NEW ELEMENTARY SCHOOL
9801 HIGHLAND KNOLLS DR
BAKERSFIELD
CALIFORNIA
93306

NEW MIDDLE SCHOOL
4115 VINELAND ROAD
BAKERSFIELD
CALIFORNIA
93306

SHEET TITLE
SINGLE LINE DIAGRAM

E-001

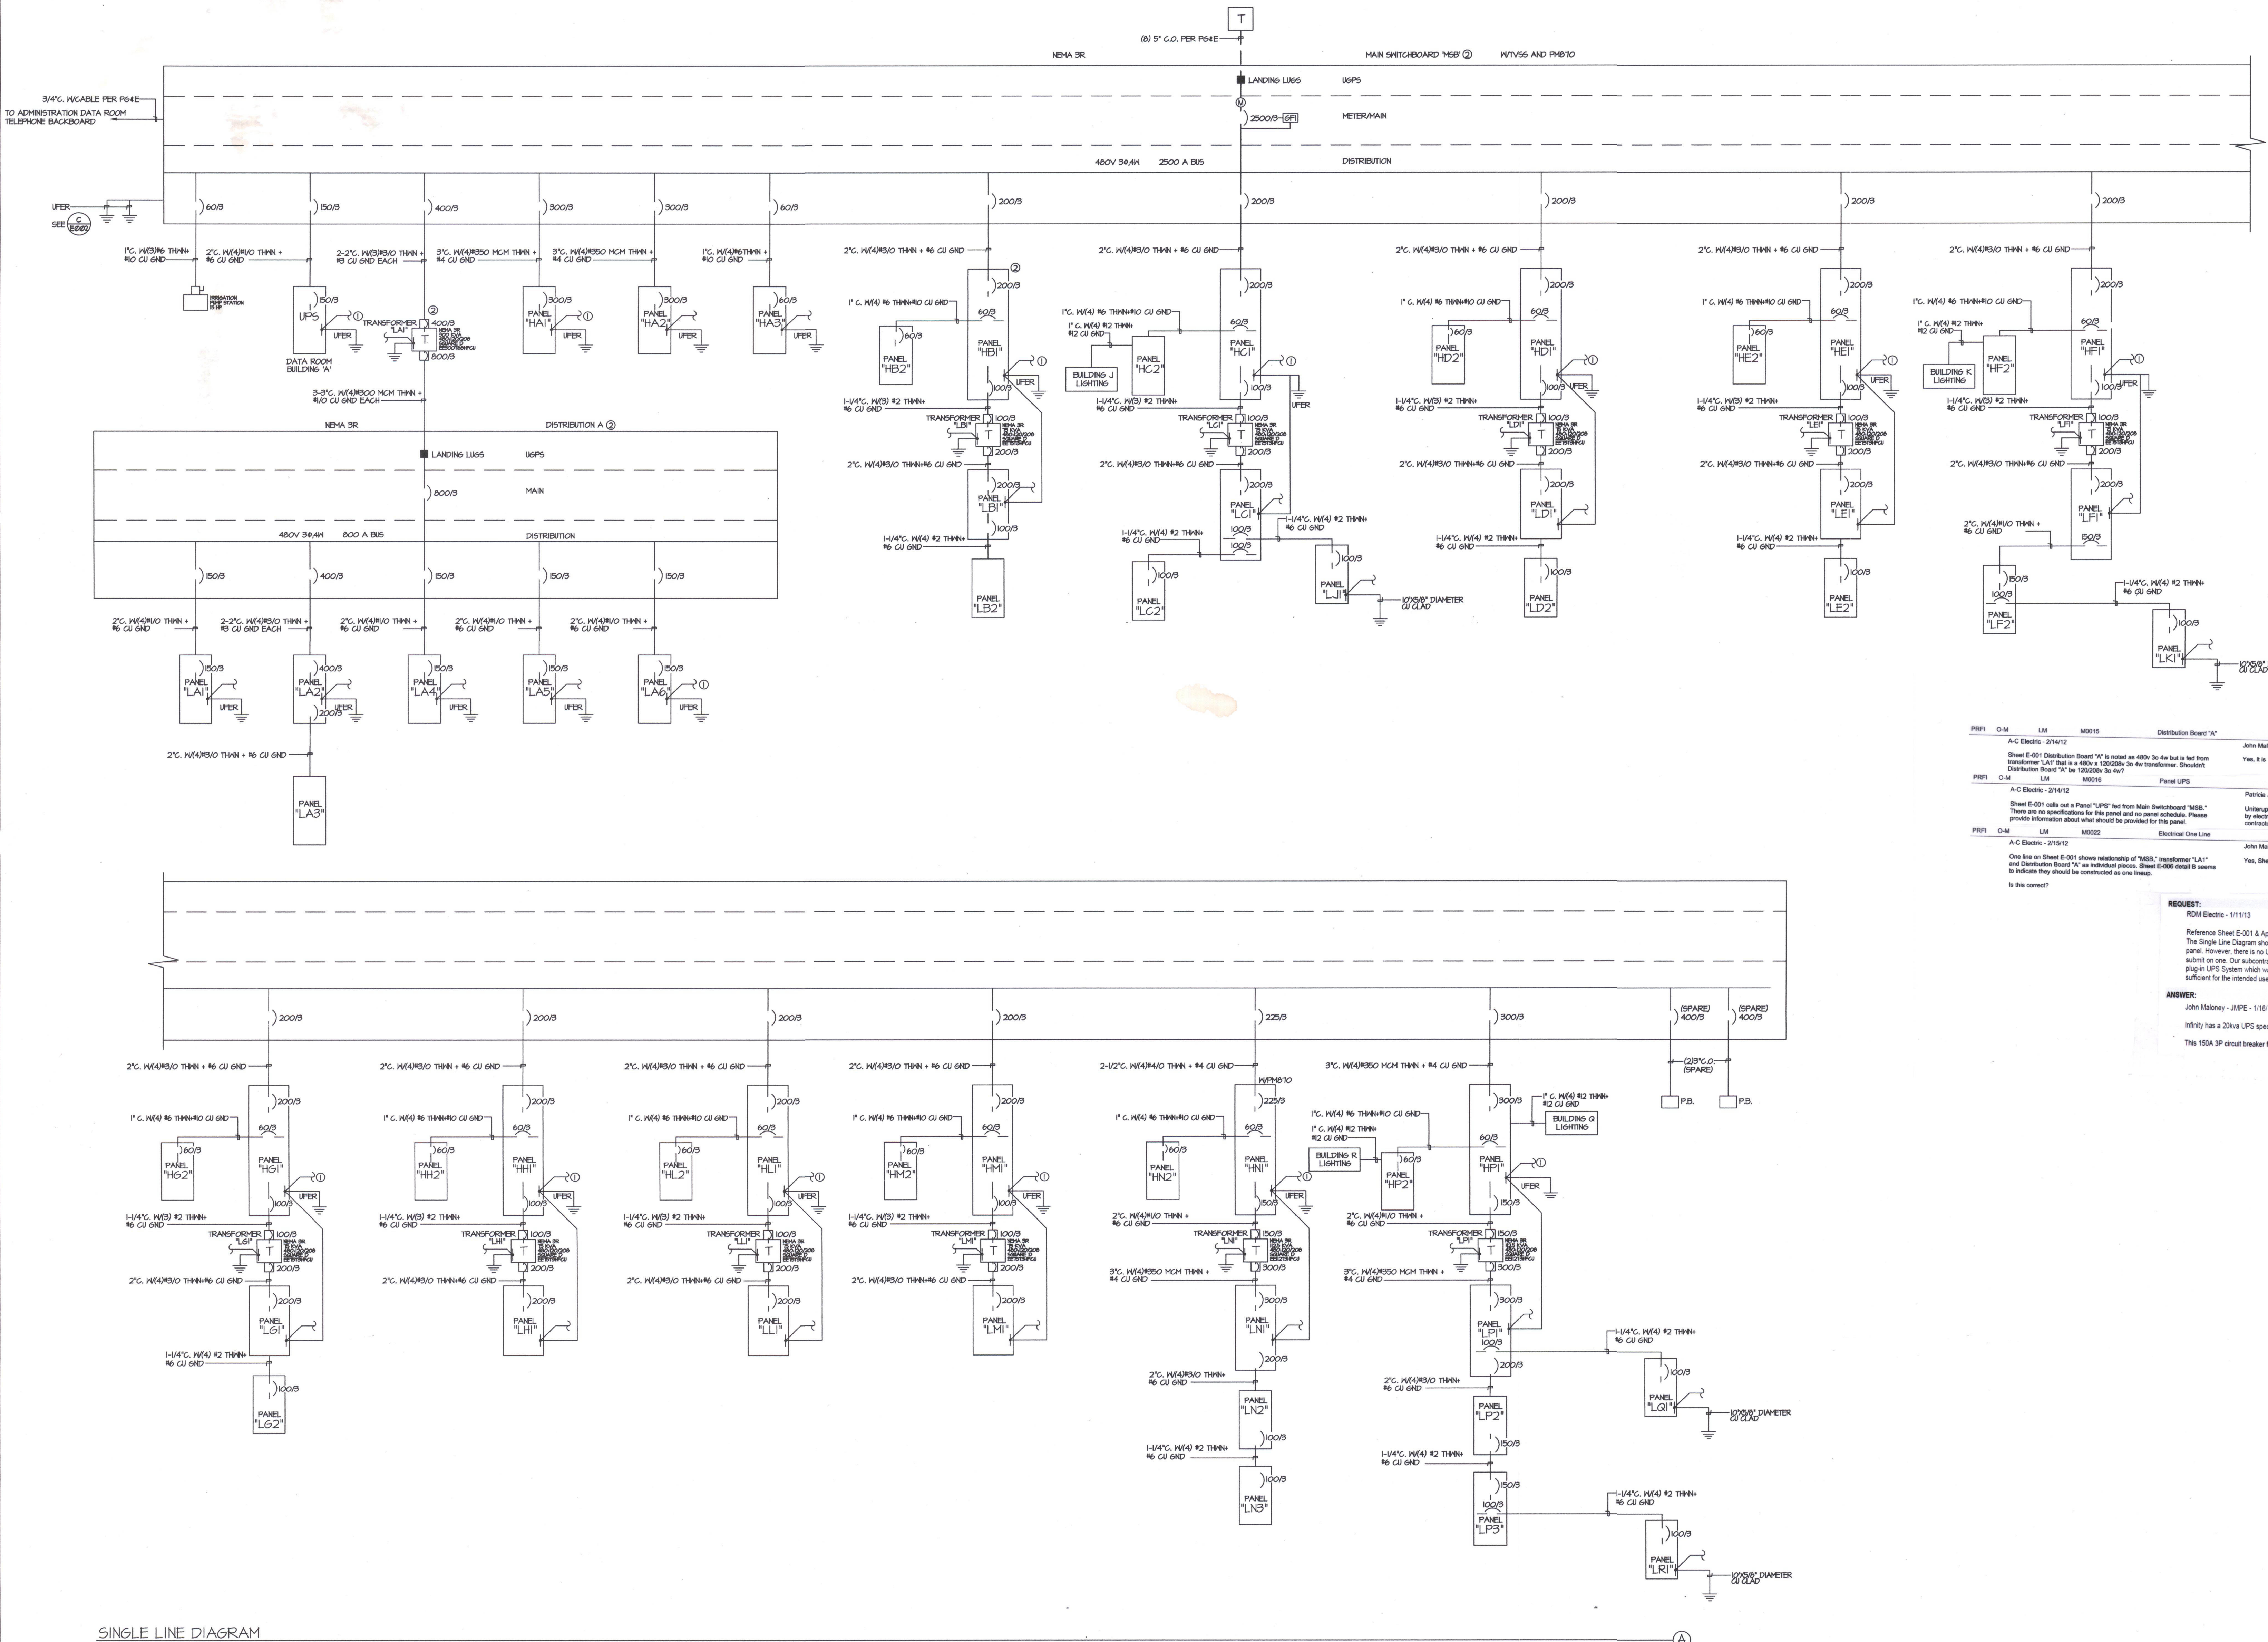
PRJ#	Q.M.	LM	MOD#	Distribution Board 'A'	CLO	2/14/2012	2/14/2012	2/14/2012
A-C Electric - 2/14/12				Sheet E-001 Distribution Board 'A' is noted as 480V 3φ but is fed from transformer 'LAT' that is a 480V, 120/208V 3φ transformer. Shown correct	John Matoney - JMPE Electrical Engineering & Lighting Design - 2/14/12	Yes	It is 120/208V 3φ 4w	
PRJ#	Q.M.	LM <td>MOD# <td>Panel UPS</td> <td>CLO</td> <td>2/14/2012</td> <td>2/23/2012</td> <td>2/21/2012</td> </td>	MOD# <td>Panel UPS</td> <td>CLO</td> <td>2/14/2012</td> <td>2/23/2012</td> <td>2/21/2012</td>	Panel UPS	CLO	2/14/2012	2/23/2012	2/21/2012
A-C Electric - 2/14/12				Sheet E-001 calls out a Panel 'UPS' fed from Main Switchboard 'MSB'. There are no specifications for the panel and no panel schedule. Please provide information about what should be provided for this panel.	Patrick J. Hayes, PE Electrical Engineer - 2/23/12	Uninterrupted power supply provided by ERATE contractor. Feeder provided by electrical contractor. Coordinate termination requirements with ERATE contractor.

PRJ#	Q.M.	LM <td>MOD#</td> <td>Electrical One Line</td> <td>CLO</td> <td>2/15/2012</td> <td>2/17/2012</td> <td>2/22/2012</td>	MOD#	Electrical One Line	CLO	2/15/2012	2/17/2012	2/22/2012
A-C Electric - 2/15/12				One line on Sheet E-001 shows relationship of 'MSB', transformer 'LAT' and Distribution Board 'A' as individual pieces. Sheet E-006 detail B seems to indicate they should be constructed as one piece.	John Matoney - 2/17/12	Yes, Sheet E-006 detail B is correct.

REQUEST:
RDM Electric - 1/11/13
Reference Sheet E-001 & Approved A/V Submittal
The Single Line Diagram shows a 150A, 3P sub-breaker which is supposed to feed a UPS panel. However, there is no UPS panel schedule provided in the plans, therefore we did not submit one. Our subcontractor, Serban Sound, submitted on a 120V, rack-mounted, plug-in UPS system which was approved. Is the UPS that was submitted by Serban Sound sufficient for the intended use or is there supposed to be an actual UPS panel? Please advise.

ANSWER:
John Matoney - JMPE - 1/16/13
Infinity has a 20kva UPS specified.
This 150A 3P circuit breaker feeds it.
